TECHNICAL SERVICE BULLETIN

MT88 Manual Transmission - Rotational Scraping Noise From Transmission When Cold And In Neutral, 1st And/Or 2nd Gear With Clutch Applied

22-2371
13 December
2022

Ford 2021-2022 Bronco	Transmission/Transaxle: MT88
---------------------------------	------------------------------

Figure 1

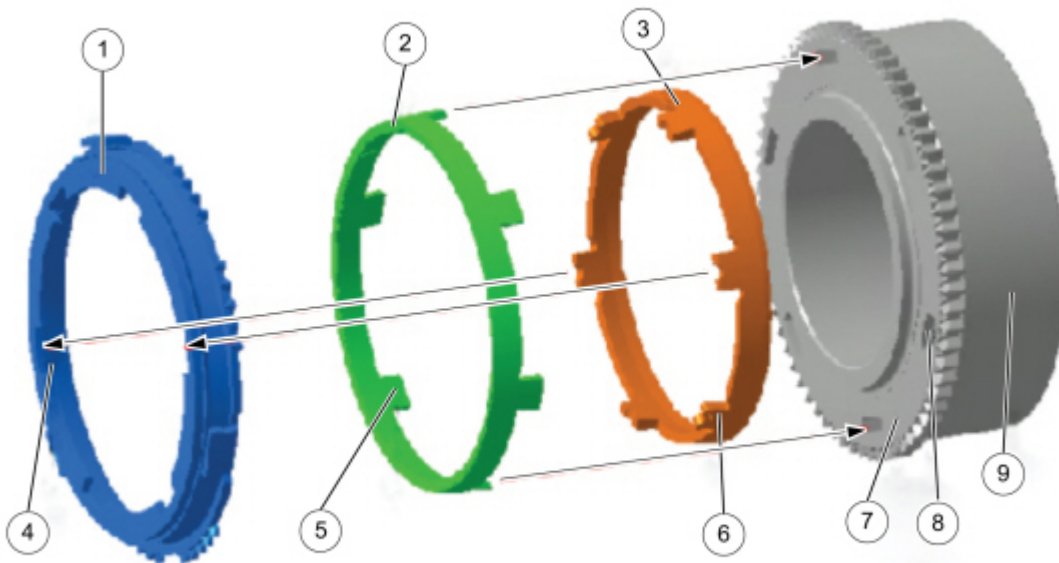
1. Remove the transmission from the vehicle, Refer to Workshop Manual (WSM), Section 308-03.
2. Disassemble the sub-assemblies to access the 5th and 6th gear synchronizer rings. Refer to WSM, Section 308-03.
3. Replace the 5th and 6th gear synchronizer rings.
4. Assemble the transmission per WSM, Section 308-03.
 - (1). The reverse/crawl gear synchronizer assembly must be assembled on the transmission. Refer to Figures 1-2 for an exploded view of the reverse/crawl gear synchronizer assembly.
